CRYSTAL CREEK ADDITION

RE: SUB 2003-28 -- Final Plat of Crystal Creek Addition

At the regular meeting of the Subdivision Committee of the Metropolitan Area Planning Commission on Thursday, May 29, 2003, the above captioned plat was considered. The action of the Committee was to approve the final plat, subject to the following staff comments:

CASE NUMBER: SUB 2003-28 -- CRYSTAL CREEK ADDITION

CRYSTAL CREEK ADDITION WICHITA, SEDGWICK COUNTY, KANSAS

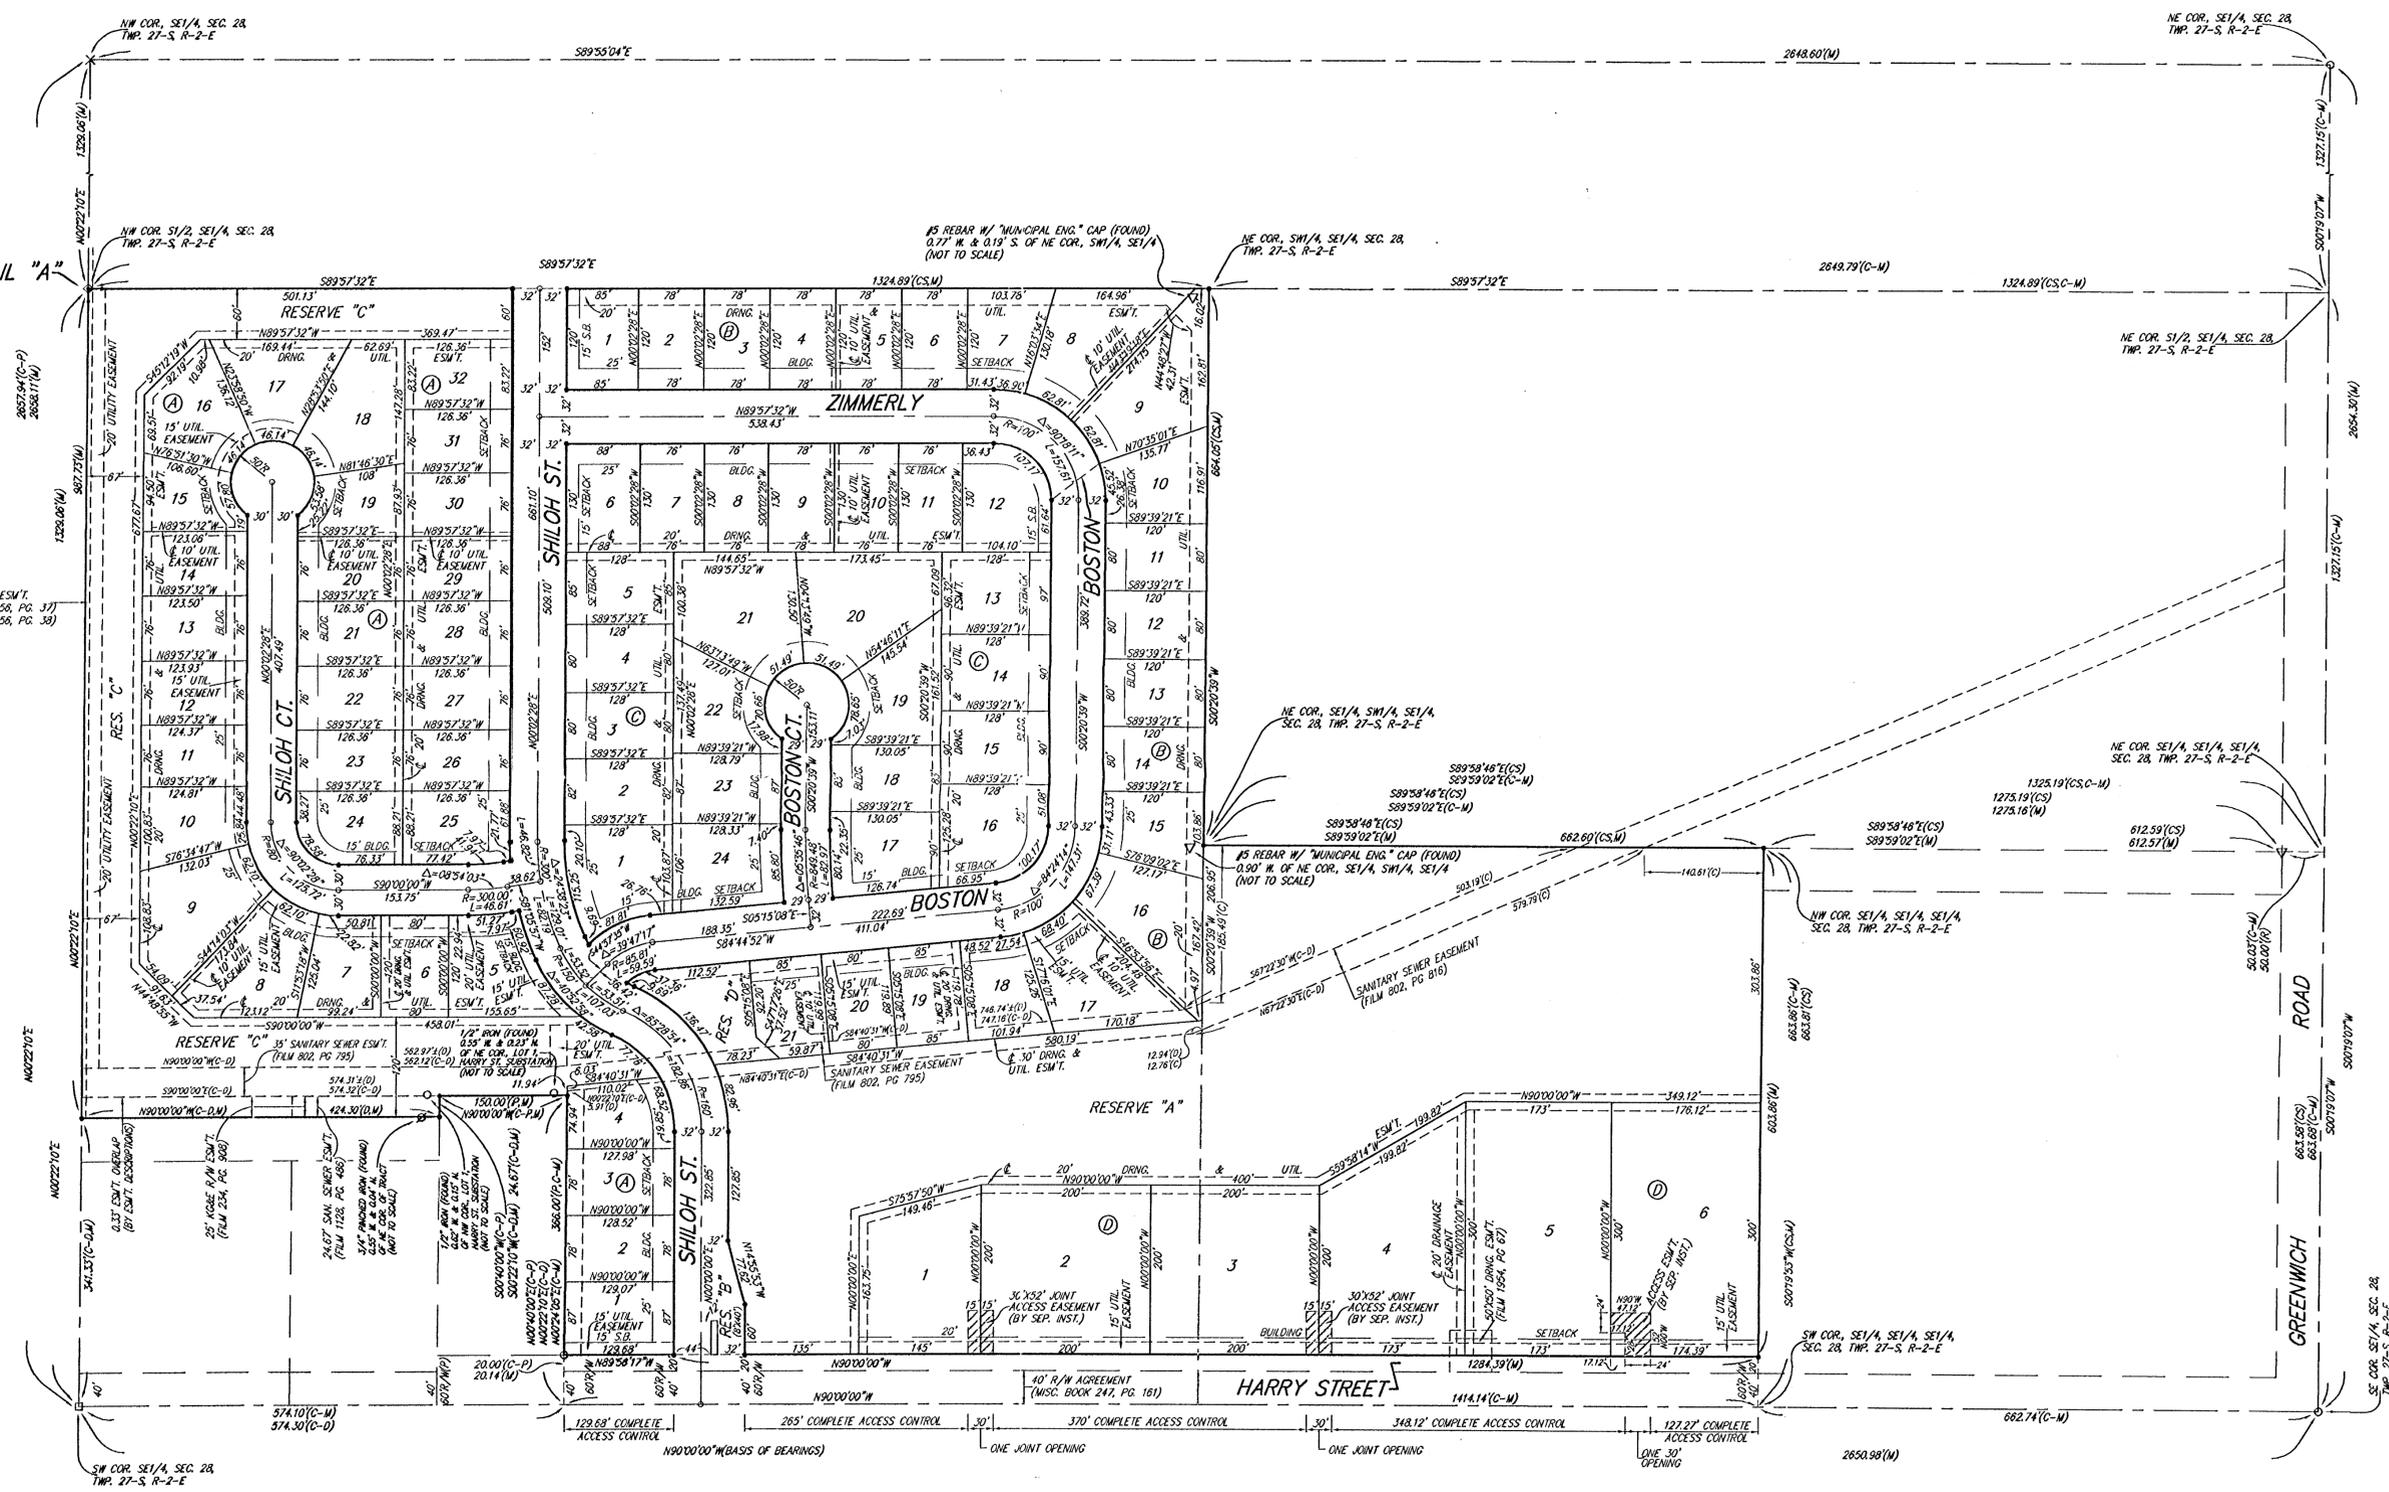
- F. The plat proposes three joint access openings for the commercial lots along Harry. Distances should be shown for all segments of access control. The final plat shall reference the dedication of access controls in the plat's text. **Traffic Engineering requests that the joint opening located between Lots 5 and 6, Block D be relocated entirely within Lot 6 to be in alignment with the major opening platted in the Smithmoor Addition across Harry. A cross-lot access agreement is needed for the benefit of Lot 5.**

- J. MAPD and **Traffic Engineering** request a street stub shown extending to the east from Smithmoor Street for increased mobility when development occurs in this location. **The Subdivision Committee did not require this connection.**

- N. Block D needs to be replaced with Block B and include Lots 22 through 27.
- O. **GIS** needs to comment on the plat's street names. **Smithmoor St. needs to be eliminated and replaced with Zimmerly and Boston. Shiloh Ct needs to be labeled.**

Access controls have been platted as requested.
